SOUTH  
KESTEVEN  
DISTRICT  
COUNCIL

## Planning Committee

### Additional Information Report

#### S20/1235

*Play area detail*

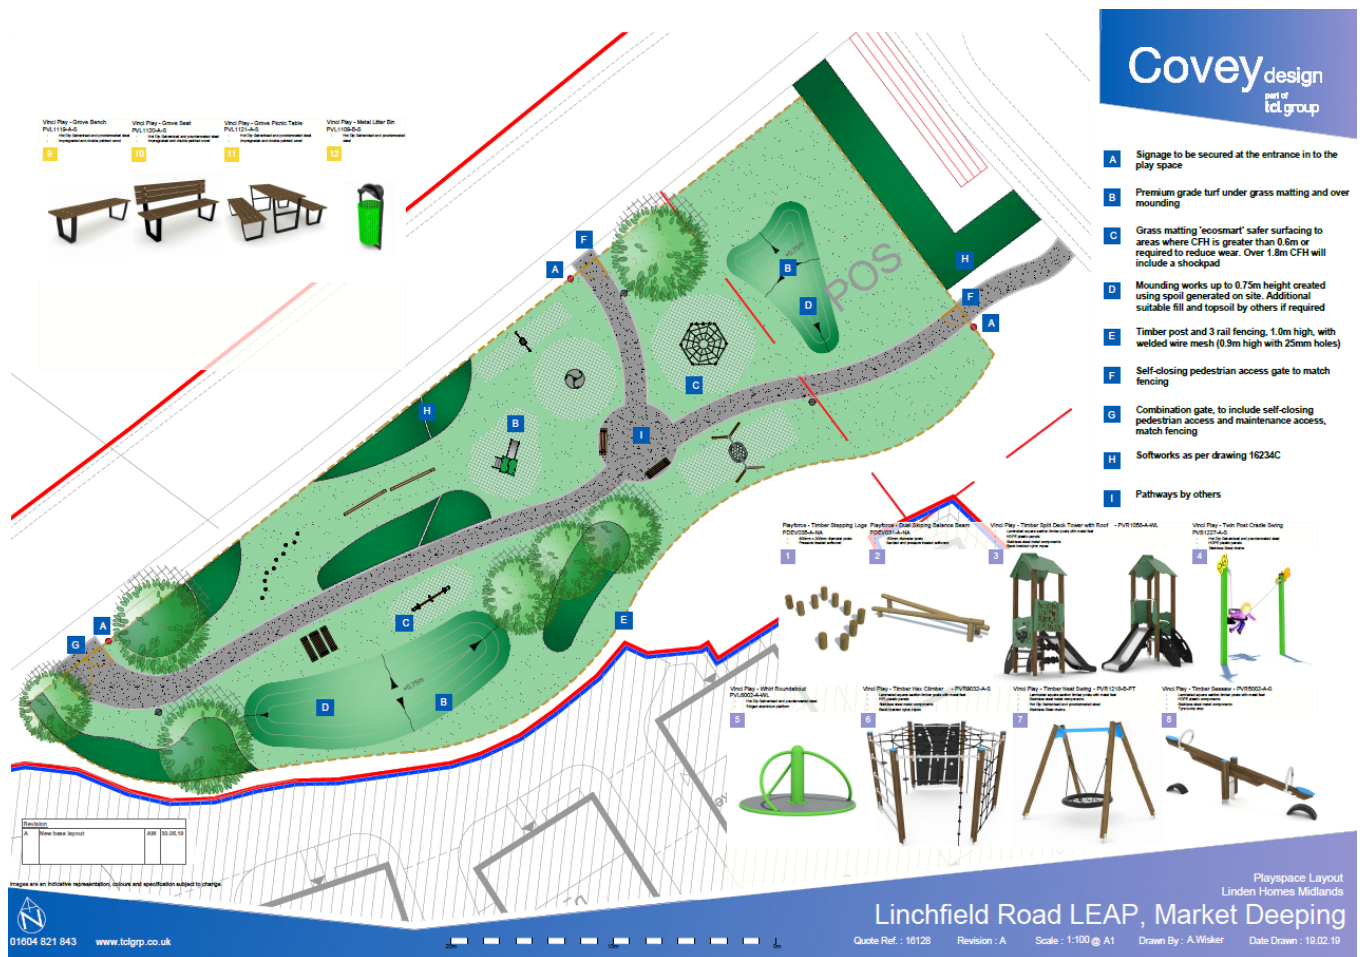
*Qu. 8 - Para.2.2 mentions that 'an equipped play area' would be incorporated. Please clarify the extent of the play area, who will pay for it, and who will maintain it?*

*Ans 8 – The play area which is within phase 1 will be provided by Linden Homes and will be maintained by a residents' management company in perpetuity. The area includes 8 pieces of play equipment, landscaping, seating areas and footpath connections to the wider site and Public Right of Way.*
